Project	<b>IEEE 802.16 Broadband Wireless Access Working Group</b> < <a href="http://ieee802.org/16">http://ieee802.org/16</a> >	
Title	<b>MSS Feedback Mechanism for MBS connections</b>	
Date Submitted	<b>2005-01-25</b>	
	Mary Chion Yonggang Fang Sean Cai Jason Hou Irving Wang	<a href="mailto:mchion@ztesandiego.com">mchion@ztesandiego.com</a>
	ZTE San Diego Inc. 10105 Pacific Heights Blvd. San Diego, CA 92121 USA	Voice: 858-554-0387 Fax: 858-554-0894
	<a href="#">Kiseon Ryu, Ronny Kim</a> <a href="#">LG Electronics</a>	
Re:	IEEE P802.16e/D5a-2004	
Abstract	This contribution provides a feedback mechanism to be used by MSSs that is subscribed to an active MBS connection. This feedback mechanism allows BS to select a more optimal DIUC for MBS data transmission.	
Purpose	Review and adopt suggested change into P802.16/D5	
Notice	This document has been prepared to assist IEEE 802.16. It is offered as a basis for discussion and is not binding on the contributing individual(s) or organization(s). The material in this document is subject to change in form and content after further study. The contributor(s) reserve(s) the right to add, amend or withdraw material contained herein.

# MSS Feed

**Figure 20x—MBS Preferred DIUC Feedback header without CID field**

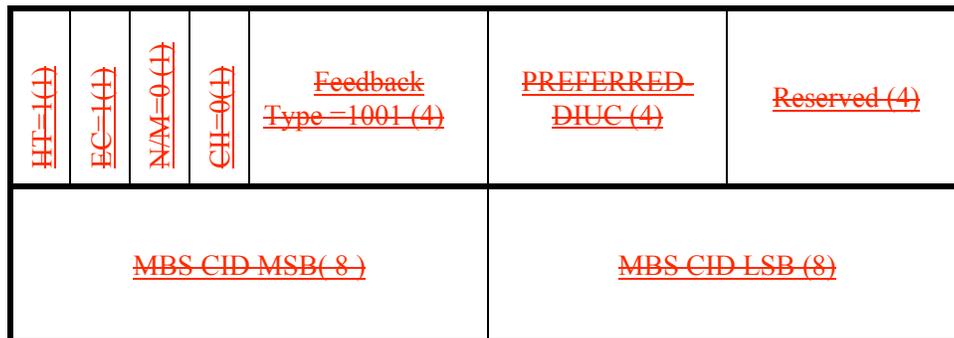
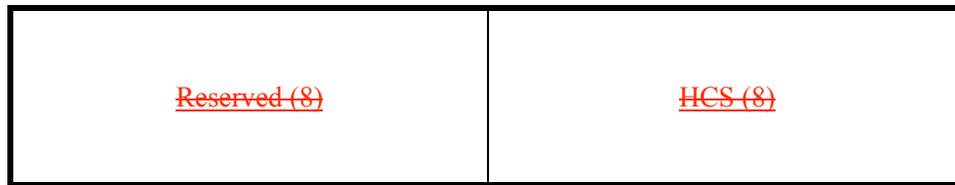
**6.3.2.1.4.4MBS Preferred DIUC Feedback header**

~~The MBS Preferred DIUC feedback header is sent by the MSS to report its preferred DIUC for a MBS connection. The MBS Preferred DIUC feedback header is only defined without CID field since BS does not need to know which MSS has sent the MBS Preferred DIUC feedback header. The MSS shall transmit the MBS Preferred DIUC feedback header to BS according to section 6.3.13.3.~~

The MBS Preferred DIUC Feedback header shall have the following properties:

- a) The length of the header shall always be 6 bytes.
- b) The Feedback TYPE field shall be “1000”
- c) PREFERRED DIUC indicates the preferred DIUC suggested by the MSS. The DIUC shall be defined in the DCD message sent by the serving BS.
- d) a) MBS CID is the CID for MBS connection that the MSS is reporting for.
